**34-11 BEACH CHANNEL DRIVE SITE**  
**34-11 BEACH CHANNEL DRIVE, FAR ROCKAWAY, NEW YORK 11691**

**CORRECTIVE MEASURES WORK PLAN**

**NYSDEC BCP Number: C-241141**

**Ref.: NYSDEC BCP# C241141**  
**34-11 Beach Channel Drive**  
**Queens, NY 11418**  
**Staten Island, NY 10305**  
**Corrective Measures Work Plan & Response to PRR Comments**

Cluster Well Installation Plan

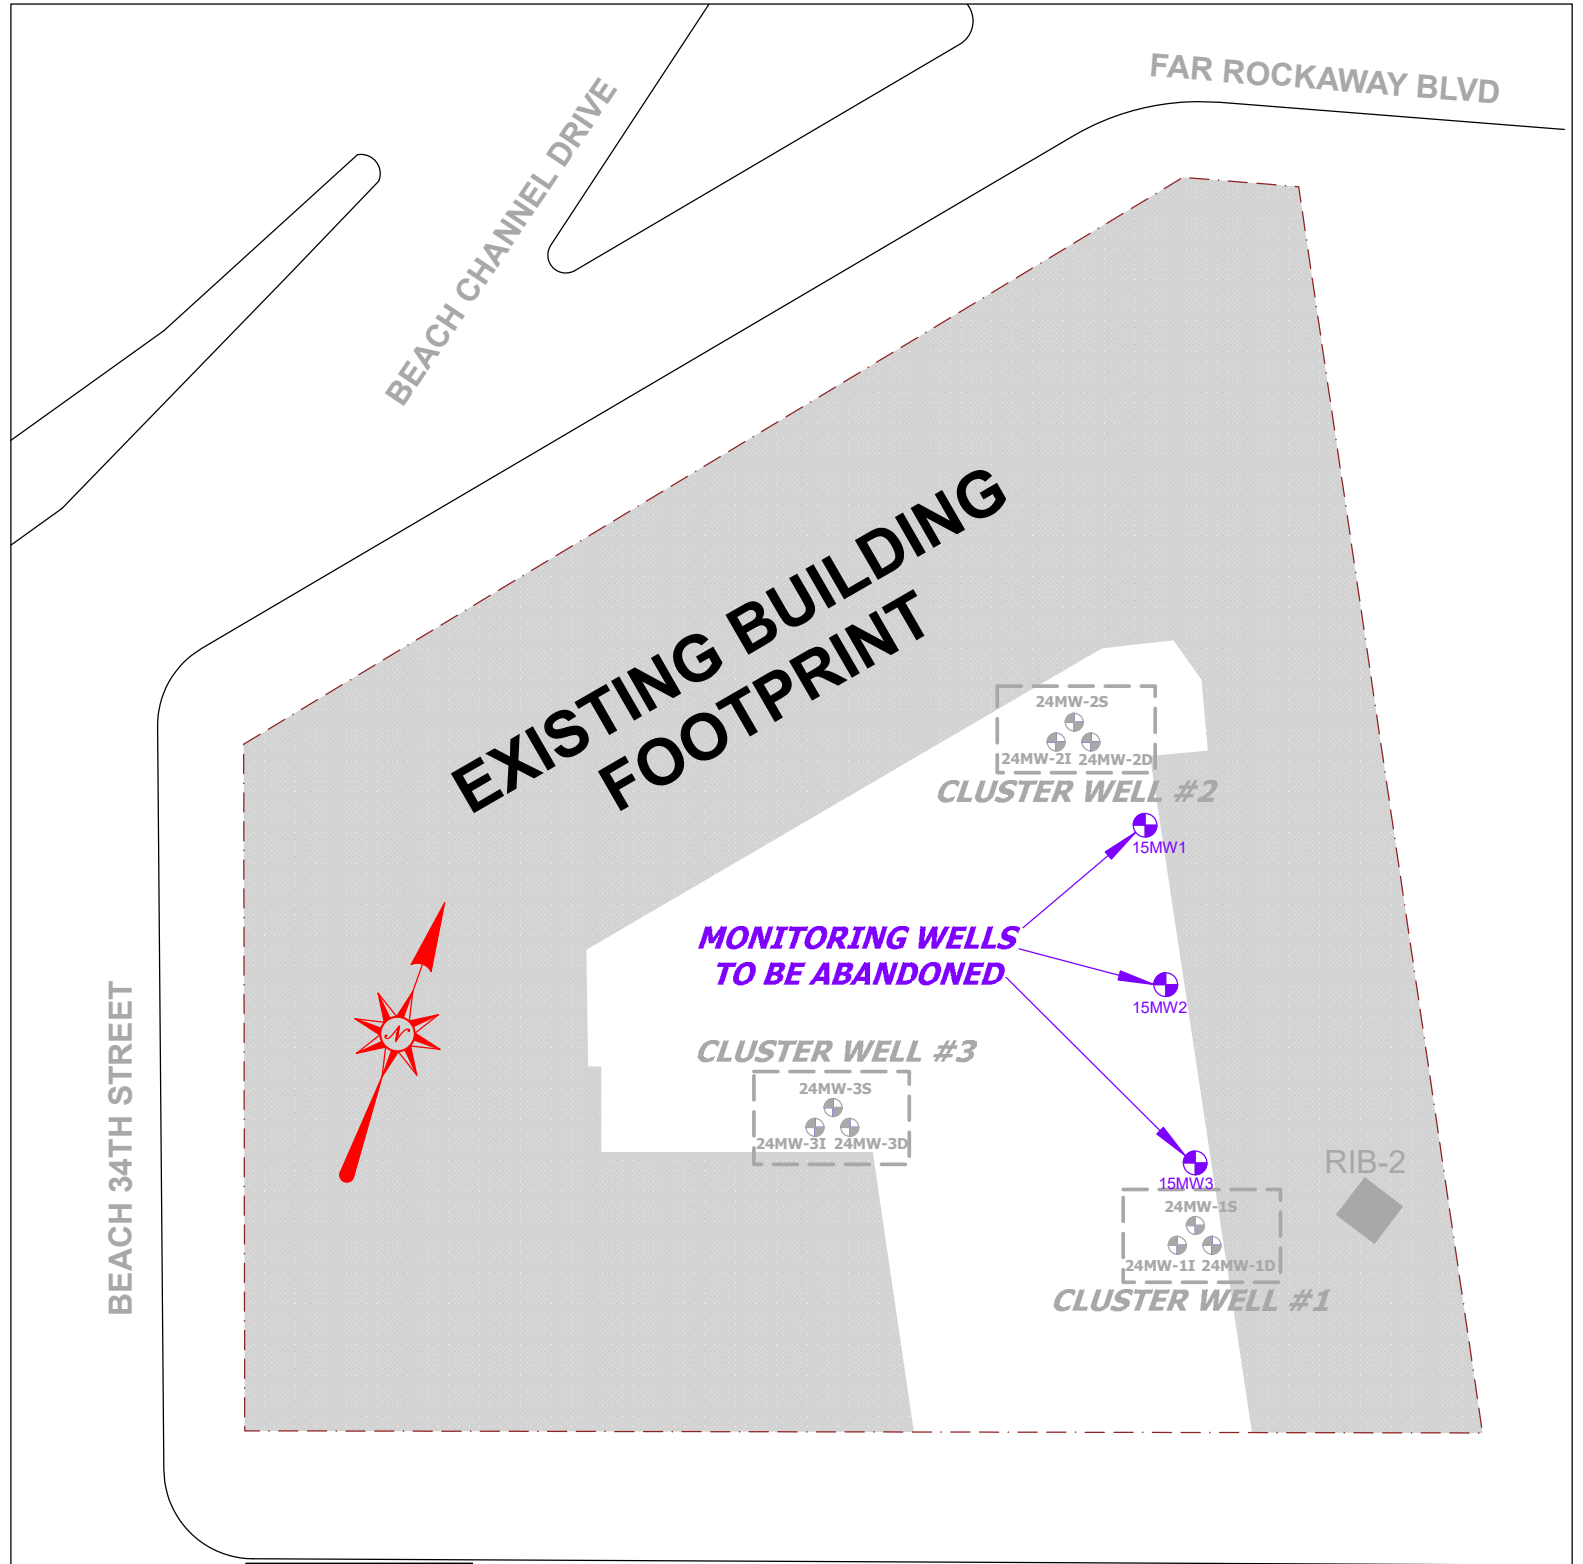
The concerns stem from the possibility that the existing groundwater monitoring wells (15MW1, 15MW2, and 15MW3) may not be properly depicting the groundwater conditions. The groundwater table starts 4-5 feet below grade, and soil CVOCs contamination were found in “RIB-2 soil boring” at 13-15’, 20-22’, and 37-39’ below grade. The existing monitoring wells are installed to a termination depth of 30’ below grade and consist of a 15’ screen and 15’ riser.

The main concerns with the existing monitoring wells are: a) the wells do not extend down to determine whether the 37-39’ contamination has been addressed, and b) the wells penetrate the clay layer (20-25’ below grade) and they are screened within the two aquifers, which may have different groundwater flow directions (as per Remedial

- The request to end ground water monitoring and shut off the sub-slab depressurization system cannot be accepted as NYSDEC has determined the monitoring wells are not installed properly, and are not providing an accurate depiction of the groundwater conditions. NYSDEC requires that additional monitoring well clusters be installed to confirm the groundwater flow direction and provide adequate groundwater quality monitoring above, within, and below the treatment area. This request has been relayed by NYSDEC in several emails and phone calls with your consultant since September 2021, with the latest request in November 2023.

1. Install three (3) new cluster wells on the job site, as shown in Figure 2. Each cluster consists of three wells (one screened for the 11-16' interval, the second screened for the 19-24' interval, and the last for the 35-40' interval), for a total of nine (9) wells.
2. Install data loggers in all nine newly proposed wells, to determine the effect of tidal influence and other factors that may influence the groundwater flow direction.
3. Survey top of casing of all new monitoring wells at the site, relative to NAVD88 datum.
4. Collect groundwater samples from 24MW-1S, 24MW-1I, and 24MW-1D, the cluster well closest to "RIB-2", to establish groundwater quality in the 13-15', 20-22', and 37-39' intervals.
5. Decommission (abandon) existing monitoring wells: 15MW1, 15MW2, and 15MW3.

A total of three (3) cluster wells are proposed to determine the direction of the groundwater flow within the upper and lower aquifers. Each cluster well will consist of three (3) monitoring wells, denoted as "Monitoring Well Shallow (MW-S)", "Monitoring Well Intermediate (MS-I)", and "Monitoring Well Deep (MW-D)". For three clusters, this is a total of nine (9) monitoring wells.

The shallow wells (24MW-1S, 24MW-2S, 24MW-3S) will be installed from grade elevation to 16' below grade. Each shallow well will consist of an 11' riser and 5' screen. The shallow wells will represent groundwater conditions from 11-16' below grade, which aims to capture the 13-15' contamination zone found during the remedial investigation.

The intermediate wells (24MW-1I, 24MW-2I, 24MW-3I) will be installed from grade elevation to 24' below grade. Each intermediate well will consist of an 19' riser and 5' screen. The intermediate wells will represent groundwater conditions from 19-24' below grade, which aims to capture the 20-22' contamination zone found during the remedial investigation. The intermediate wells also represent the groundwater quality within the injection zone.

The deep wells (24MW-1D, 24MW-2D, 24MW-3D) will be installed from grade elevation to 40' below grade. Each deep well will consist of a 35' riser and 5' screen. The deep wells will represent groundwater conditions from 35-40' below grade, which aims to capture the 37-39' contamination zone found during the remedial investigation.
